REQUEST FOR COMMITTEE ACTION

HENDERSON COUNTY TECHINCAL REVIEW COMMITTEE

SUBJECT: Combined Master and Development for Rugby Ridge Major Subdivision

Combined Master and Development Plan Rugby Ridge (2018-M09)

Map E: Water Supply Watershed

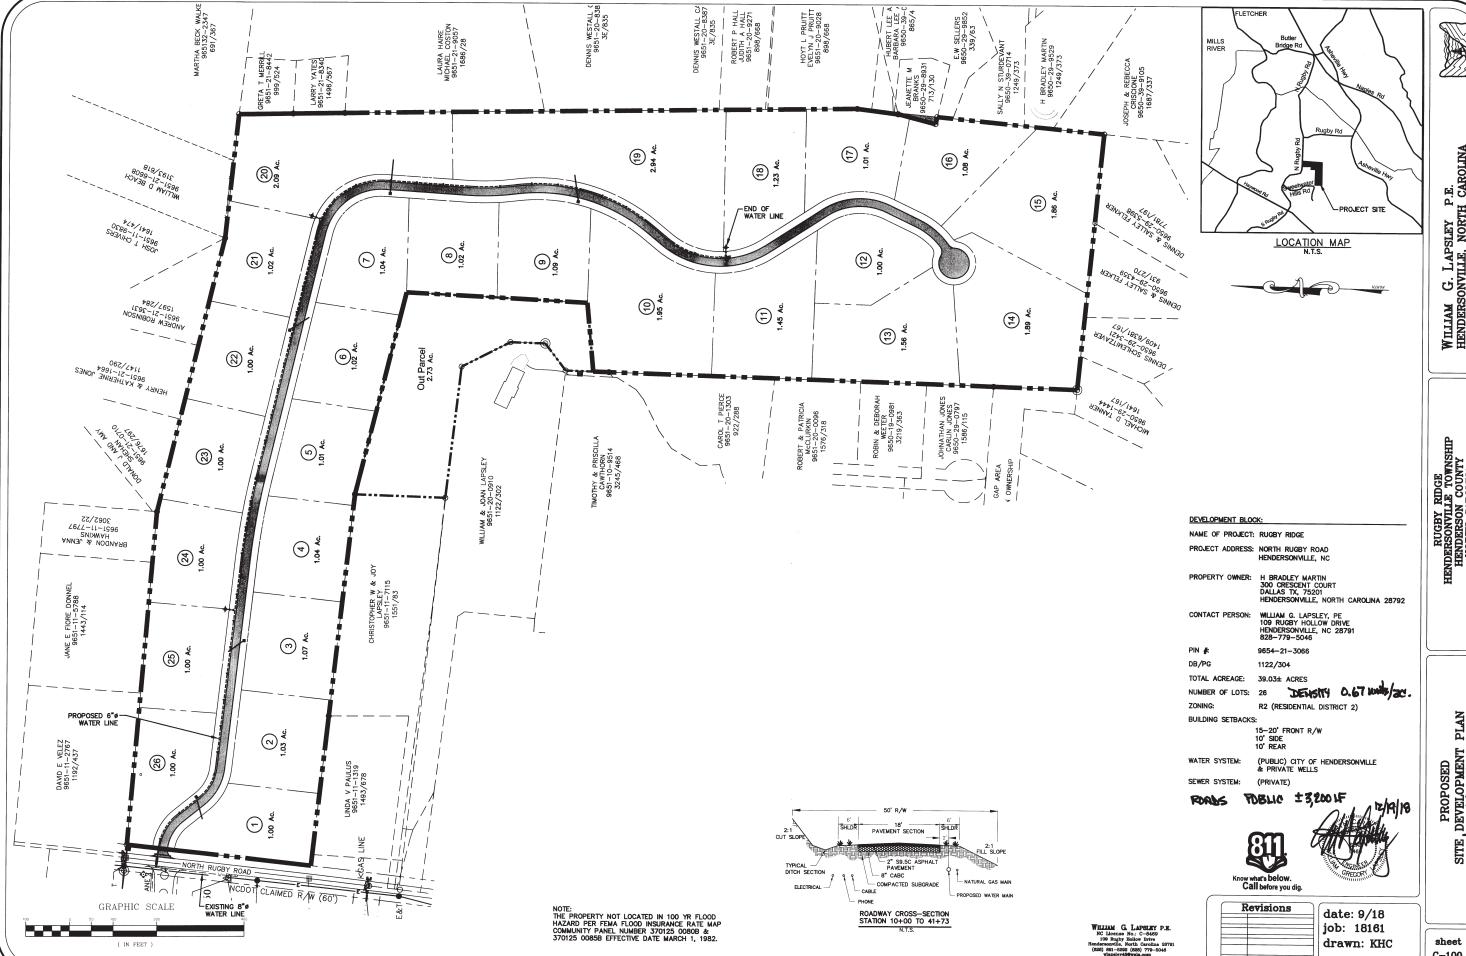
- **5. Water Supply Watershed:** The project site is partially in the Upper French Broad River watershed WS-IV PA.
 - a. The low density option allows for average lot size of 20,000 sq. ft. minimum or maximum of 24% built-upon area. This proposed subdivision meets these requirements for Water Supply Watershed protection regulations.

C-100

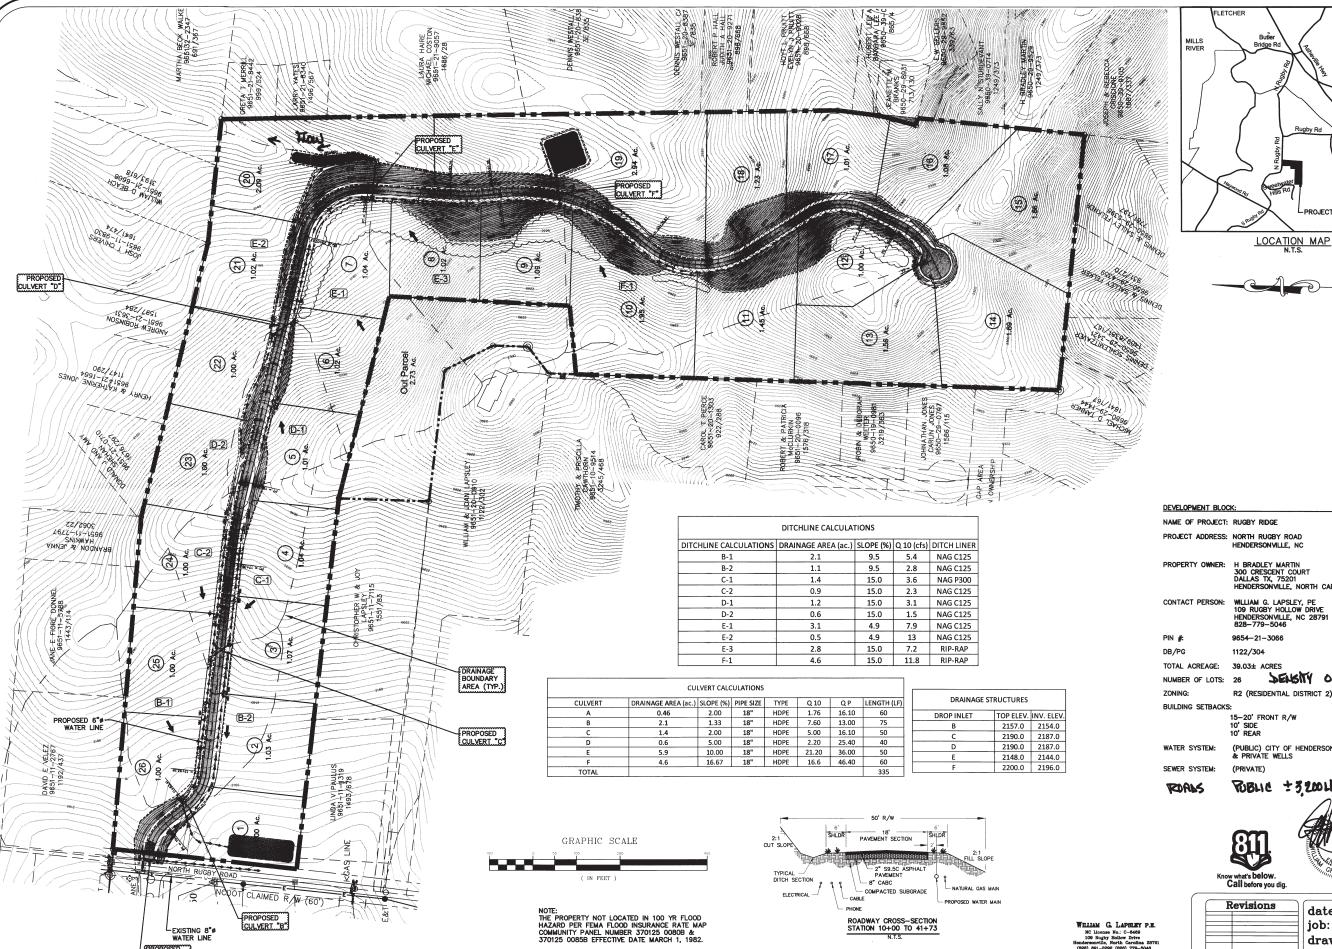
- 1. There is a 2.73 acre outparcel shown on the master plan that will be combined with parcel 9651-20-0910 owned by William and Joan Lapsley.
- 2. **Soil Erosion and Sedimentation Control Plan.** The Applicant shall submit written notice from the appropriate local agencies verifying that an Erosion and Sedimentation Control Plan has been received or a written notice from a professional land surveyor, engineer, landscape architect, architect, or professional planner certifying that no plan is required (LDC §42A-113B).

- 3. **Public Roads.** The final plat(s) must indicate that the proposed road (Rugby Ridge Drive) has been designed and constructed in accordance with State Road Standards and has been offered dedication to the public

- 6. **Street Tree Requirements.** According to the street tree requirements of Chapter 42A (LDC §42A-145 and LDC §42A-146) the applicant must provide one tree per 50 linear feet of property abutting an internal road. Trees may be placed in groups with a minimum spacing of no less than 15 feet and a maximum spacing of no more than 65 feet. The trees may be placed within the right-of-way or within 20 feet of the edge of the right-of-way. The applicant may use existing trees in accordance with LDC §42A-153 instead of planting new trees. These existing trees must also be located within the right-of-way or 20 feet off the edge of the right-of-way as required by LDC §42A-146
